DETAILED ACTION

Drawings

Reproduced from U.S. Publication No. 2001/0029708

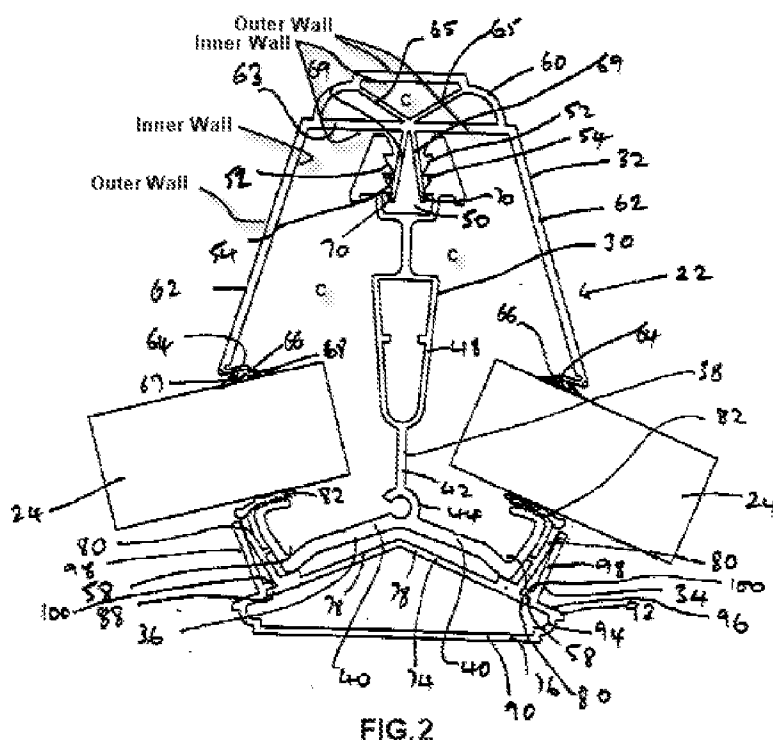
7. Regarding claim 1, Richardson discloses in Fig. 2 a capping (32, 34) of plastics material for location on a structural member (30) of a conservatory roof wherein the capping is twin-walled (60, 63) and has means for location (69) thereof on the structural member.

8. Regarding claim 25, Richardson discloses a glazing bar (30) and an upper capping (32) therefore and means for locating (69) the capping on the glazing bar, the glazing bar having a stem (48) and a lateral flange means for supporting (40) roofing panels (24) directly or indirectly, and wherein the upper capping comprises at least a twin wall construction (60,63).

11. Regarding claims 4 and 27, Richardson discloses a capping that has twin wall

construction that has an inner (Inner Wall) and outer wall (Outer Wall) having a plurality of spaced webs (65) extending there between to divide the twin wall construction into a plurality of chambers. The examiner notes that the limitation of "to divide..." is intended use language and considers the and considers the spacing webs of Richardson to meet the limitations.

12. Regarding claims 5 and 28, Richardson discloses additional walls (62) to form further chambers ("C").
13. Regarding claims 8 and 31, Richardson discloses a capping that has a top (60) and two depending sides (62).

14. Regarding claims 9 and 32, Richardson discloses a gasket along the edges (66) for sealing on roofing panels retained on the glazing bar.
15. Regarding claims 10 and 33, Richardson discloses the edges (64) of the depending sides (62) of the capping (32, 34) extend between the ends on the inner and outer walls of the capping.

16. Regarding claims 11 and 34, Richardson discloses a gasket (66) that forms part of the edge (64) that spans the gap between the ends of the inner and outer walls. The examiner considers the gap to be the thickness of the wall of the capping that separates the inner and outer wall with the gasket spanning the length.

17. Regarding claims 12 and 35, Richardson discloses a gasket that includes a body (64) connecting with the capping and lips (67,68) which brand from the body and engages the roofing panel (24).

18. Regarding claims 13 and 36, Richardson discloses an inner wall (Inner wall) that terminates at a greater distance from the roof panel (24) than the outer wall so that the gasket is at least partially concealed by the outer wall (Outer Wall).

upper capping (32) therefor and means for locating (69) the capping on the bar, and wherein the glazing bar has a stem (48) and lateral flange means for supporting (40) roofing panels (24), and wherein the space within the capping between the stem and the roofing panel is divided into at least two chambers.

Reproduced from U.S. Patent No. 6,347,495

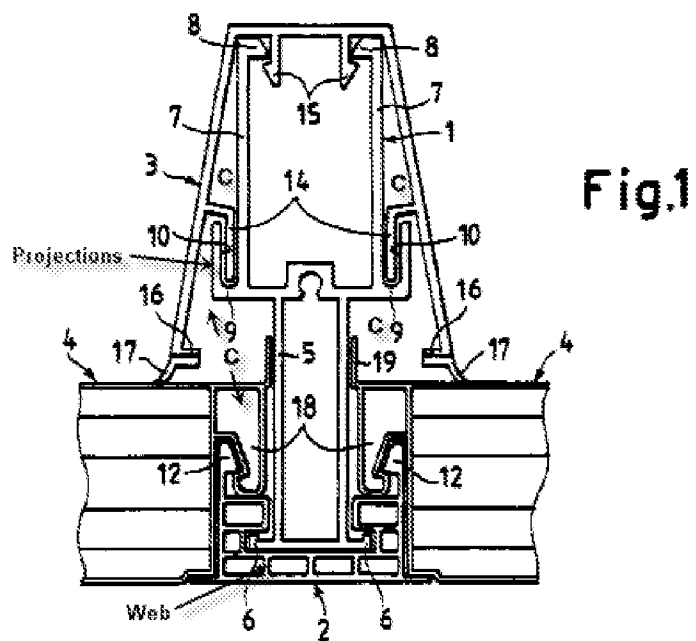
27. Claims 52-59 are rejected under 35 U.S.C. 102(b) as being anticipated by Conterno (U.S. Patent No. 6,347,495).
28. Regarding claim 52, Conterno discloses in Fig. 1 a glazing bar (1) and an upper capping (3) therefor and means for locating (15) the capping on the bar, and wherein the glazing bar has a stem (7) and lateral flange means for supporting (2) roofing panels (4), and wherein the space within the capping between the stem and the roofing panel is divided into at least two chambers ("c").

29. Regarding claim 53, Conterno discloses “ducts” that are divided into inner and outer chambers (“c”).
30. Regarding claim 54, Conterno discloses a division that is by means of projections (Projections) formed on the stem and extending towards the inside wall of the capping.

31. Regarding claim 55, Conterno discloses a division that is formed by projections (14) that “depend” from the inside of the capping. The examiner considers the projections that are formed on the stem and depend on the capping to collectively contribute to the division.

32. Regarding claim 56, Conterno discloses projections (projections) that extend up to the stem (7).
33. Regarding claim 57, Conterno discloses in Fig. 6 a projections (14) that does not make physical contact with the stem(1). The examiner considers the clearance in the channel to be sufficient to prevent contact.

34. Regarding claim 58, Conterno discloses projections (projections) that branch from the stem and stop “short” of the capping.
35. Regarding claim 59, Conterno discloses projections that are arcuate. The examiner considers the portion of the projection that is arcuate in cross section to meet the limitation.

Fig. 6

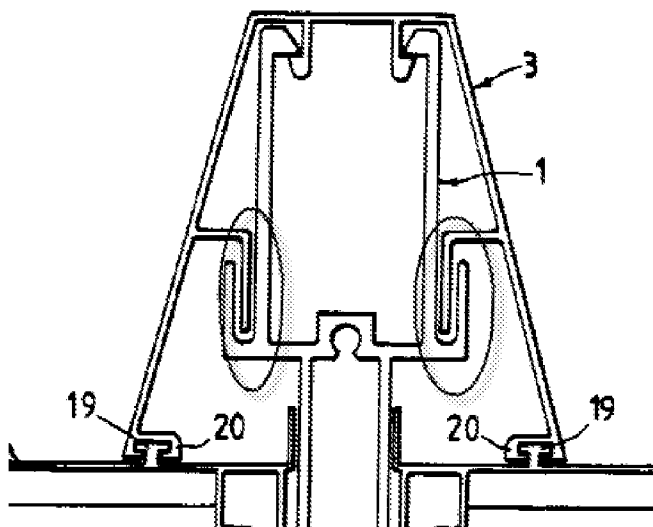
47. Regarding claim 48, Conterno further discloses projections (projections) that extend up to the stem (7).
48. Regarding claim 49, Conterno further discloses in Fig. 6 a projections (14) that does not make physical contact with the stem(1). The examiner considers the clearance in the channel to be sufficient to prevent contact.
